City of Alachua

Planning & Community Development Department Staff Report

SUBJECT:	A request for a Site Plan to construct a $\pm 1,080$ square foot fire station and a $\pm 1,080$ square foot apparatus building, with associated site improvements
APPLICANT/AGENT:	Monique Heathcock, P.E., LEED AP, CHW
PROPERTY OWNER:	Phoenix Commercial Park, LLP
LOCATION:	North of US Highway 441, west of CSI Academy, and east of Phoenix Commercial Park
PARCEL ID NUMBERS:	A portion of Tax Parcel Number 05855-004-000
FLUM DESIGNATION:	Industrial
ZONING:	Light & Warehouse Industrial (ILW)
OVERLAY:	N/A
ACREAGE:	± 1.03 acres
PROJECT PLANNER:	Justin Tabor, AICP
RECOMMENDATION:	Staff recommends that the Planning & Zoning Board approve the Site Plan, subject to the five (5) conditions provided in Exhibit "A" and located on page 21 of the June 11, 2019 Staff Report to the Planning & Zoning Board.
RECOMMENDED MOTION:	<i>Based upon the competent substantial evidence presented at this hearing, the presentation before this Board, and Staff's recommendation, this Board finds the application to be consistent with the City of Alachua Comprehensive Plan and in compliance with the Land Development Regulations and appr

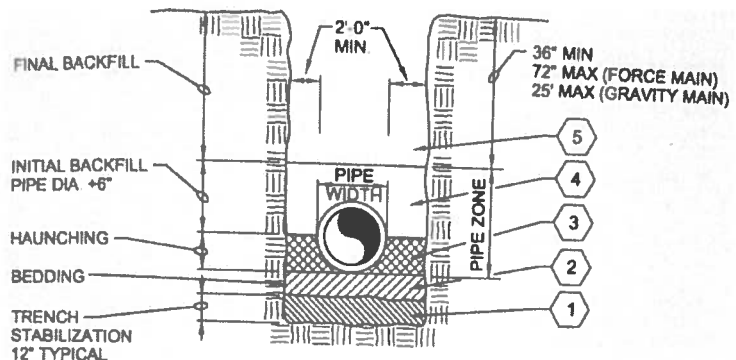
NO.	COMMENTS
7.	<p>April 30th Comment</p> <p>C210</p> <p>Please provide a cleanout in the P-WW line. Locate this cleanout in the easement near the easement line. This will allow the City ready access to the cleanout.</p> <p>Please Revise and Resubmit this drawing.</p> <p>May 20th Comment</p> <p>Approved.</p>

8.	<p>May 20th Comment</p> <p>C2.31: CoA Standard Detail 410 needs modification. Please revise as shown below:</p>  <p>NOTES:</p> <ol style="list-style-type: none"> 1. TRENCH STABILIZATION SHALL BE PROVIDED TO A DEPTH OF 12-INCHES. THE MATERIAL SHALL BE NO. 57 STONE. 2. BEDDING SHALL BE A MINIMUM OF 6-INCHES AND COMPOSED OF IMPORTED GRANULAR FILL. COMPACT TO 95% STANDARD PROCTOR, AASHTO T-99. 3. HUNCHING PORTION OF THE PIPE ZONE SHALL BE PLACED TO THE SPRINGLINE OF THE PIPE AND COMPOSED OF IMPORTED GRANULAR FILL. COMPACT TO 95% STANDARD PROCTOR ASSHTO T-99. 4. INITIAL BACKFILL: COMMON FILL COMPACTED TO 95% (98% UNDER PAVEMENT) OF THE MAXIMUM DENSITY AS PER AASHTO T-180. FROM THE SPRINGLINE OF THE PIPE TO TWO (2) FEET ABOVE THE PIPE THE SOIL SHALL BE CAREFULLY BACKFILLED IN 6-INCH LIFTS AND THE SOIL CONSOLIDATED WITH THE HAND OPERATED TAMPING MACHINE (OR AS REQUIRED BY CITY, COUNTY, OR STAT INSPECTORS). 5. FINAL BACKFILL: COMMON FILL COMPACTED TO 95% (98% UNDER PAVEMENT) OF THE MAXIMUM DENSITY AS PER AASHTO T-180. AFTER PLACEMENT AND COMPACTION OF THE INITIAL BACKFILL, THE BALANCE OF THE BACKFILL MATERIAL MAY BE MACHINE PLACED OR AS REQUIRED BY THE INSPECTOR AND SHALL NOT CONTAIN ANY ROCKS OR DEBRIS. 6. WATER SHALL NOT BE PERMITTED IN THE TRENCH DURING CONSTRUCTION. 7. ALL PIPE TO BE INSTALLED WITH BELL FACING UPSTREAM TO THE DIRECTION OF THE FLOW. 8. DEPTH FOR REMOVAL OF UNSUITABLE MATERIAL SHALL GOVERN DEPTH OF BEDDING ROCK BELOW THE PIPE. UTILITIES SHALL DETERMINE IN THE FIELD REQUIRED REMOVAL OF UNSUITABLE MATERIAL TO REACH SUITABLE FOUNDATION. THE BOTTOM OF THE TRENCH SHALL NOT BE EXCAVATED BELOW THE SPECIFIED GRADE. IF UNDERCUTTING OCCURS, THE BOTTOM OF THE TRENCH SHALL BE BROUGHT UP TO THE ORIGINAL GRADE WITH APPROVED MATERIAL AND THOROUGHLY COMPACTED TO A MINIMUM OF 95% MODIFIED PROCTOR.
